NO.	REVISIONS	DATE
1	ADDENDUM 1	06/17/2020
2	ADDENDUM 2	07/09/2020
3	PROPOSAL REQUEST 1	07/23/2020
4	ADDENDUM 3	07/28/2020
5	PI #3	08/17/2020

DRAWING TITLE:  
**LEVEL 03 MECHANICAL PLAN**

DRAWING NUMBER:  
**M2.03**

**1 LEVEL 03 MECHANICAL PLAN**  
SCALE: 3/32"=1'-0"

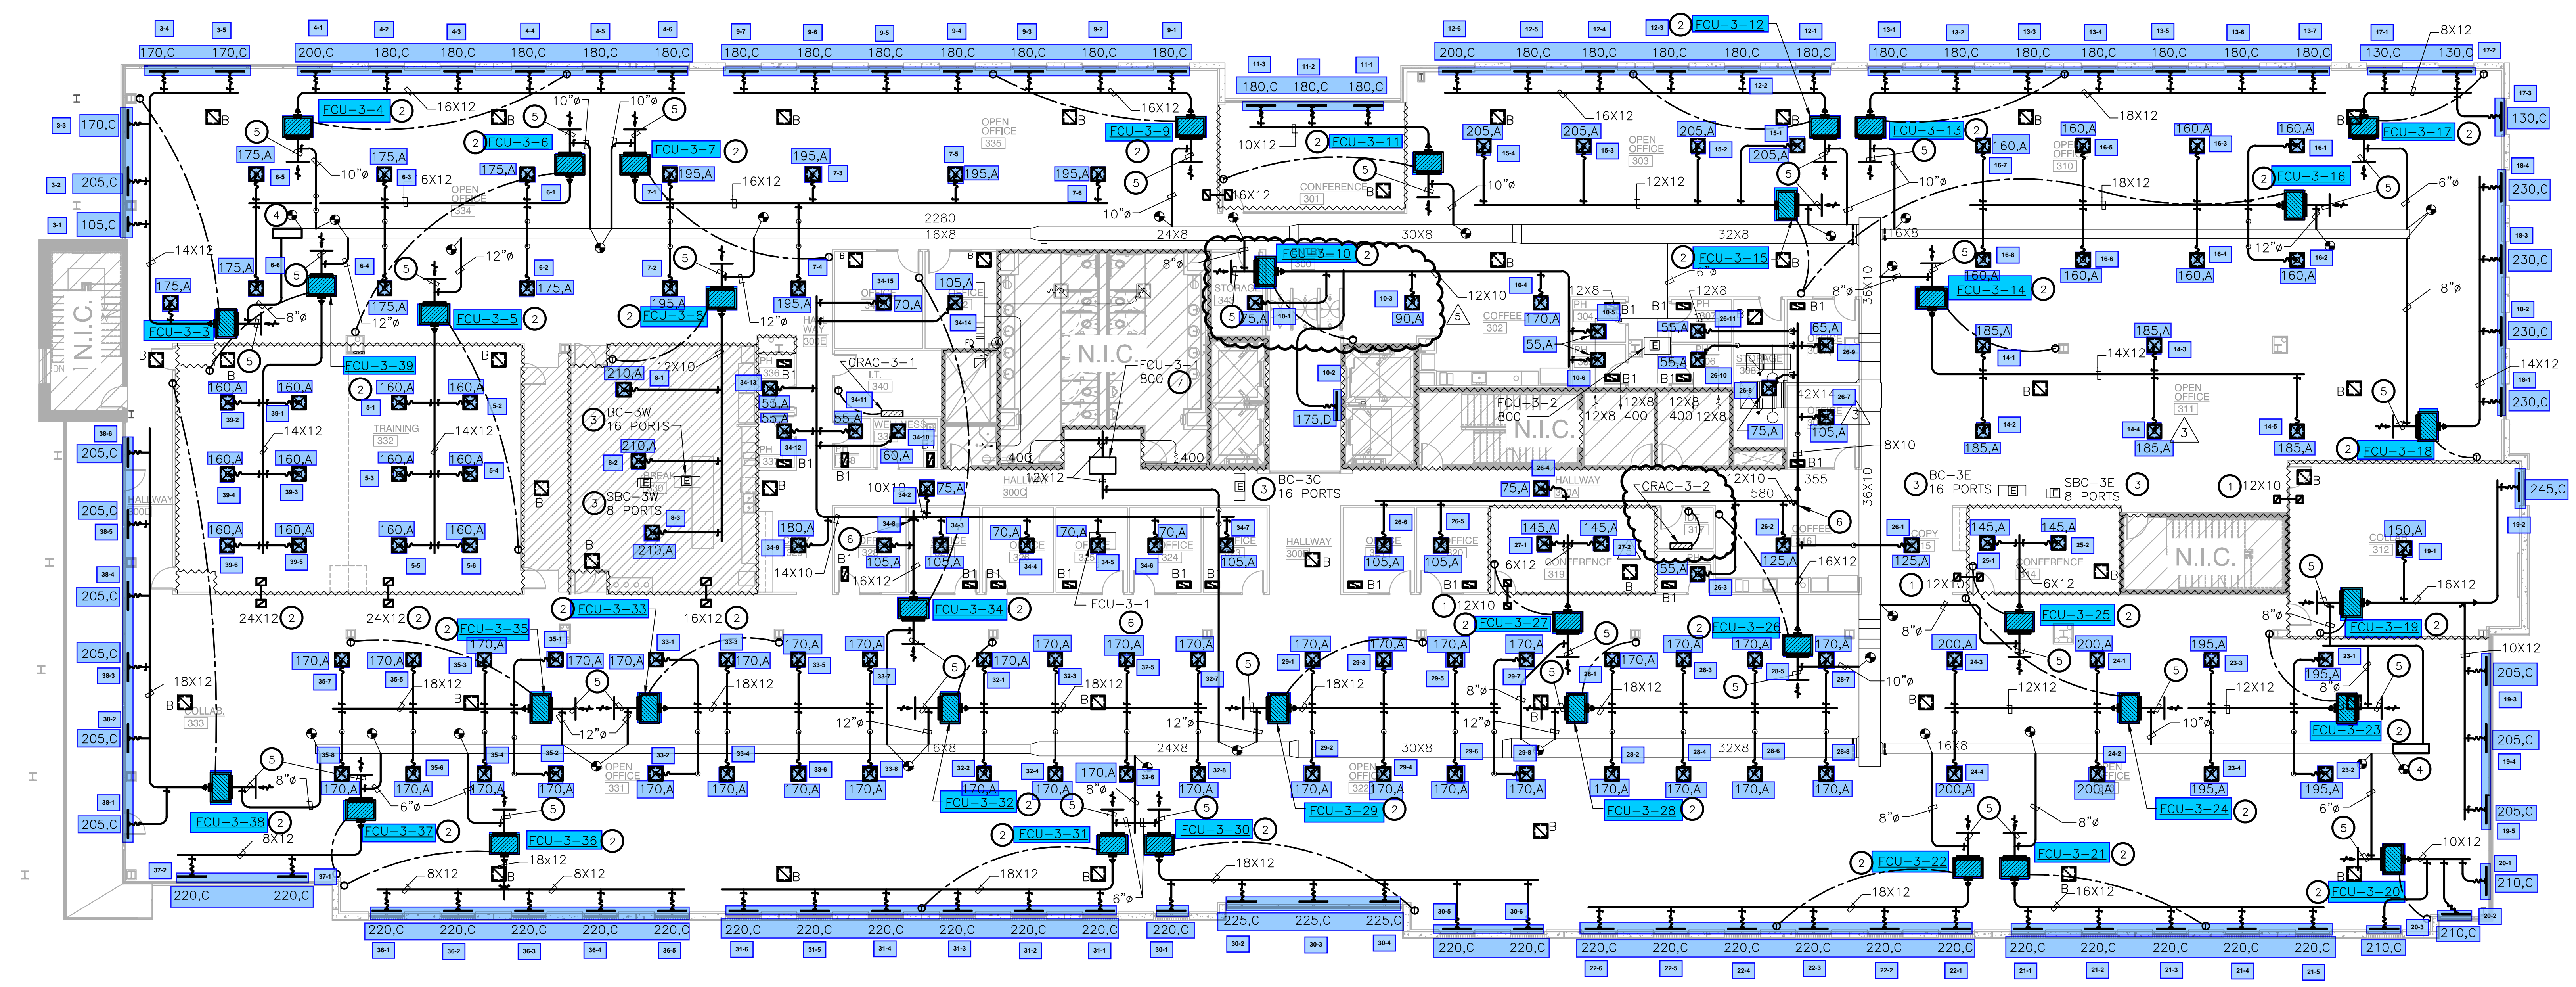
- REVISION SUMMARY:
- RELOCATED SUPPLY GRILLE AND ADDED RETURN AIR GRILLE TO NEW STORAGE ROOM.
  - ADDED CRAC UNIT TO NEW DF ROOM.
